MILITARY SPECIFICATION

MICROCIRCUITS, DIGITAL, BIPOLAR, SCHOTTKY TTL, MULTIPLE NOR GATES, MONOLITHIC SILICON

This amendment forms a part of MIL-M-38510/73A, dated 7 September 1983 and is approved for use by all Departments and Agencies of the Department of Defense.

FIGURE 1. Logic diagram and terminal connections (top view).

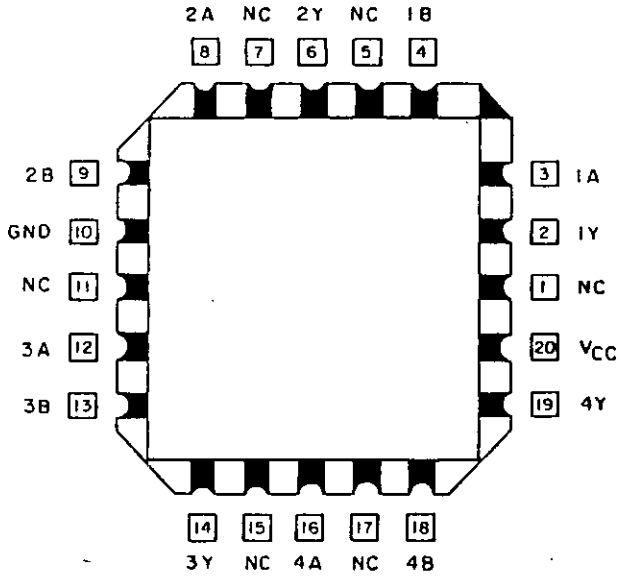
* 1.2.3, add the following case outline:

"2 C-2 (20-terminal, .350" x .350") square chip carrier package
X C-2A (20-terminal, .350" x .350") square chip carrier package"
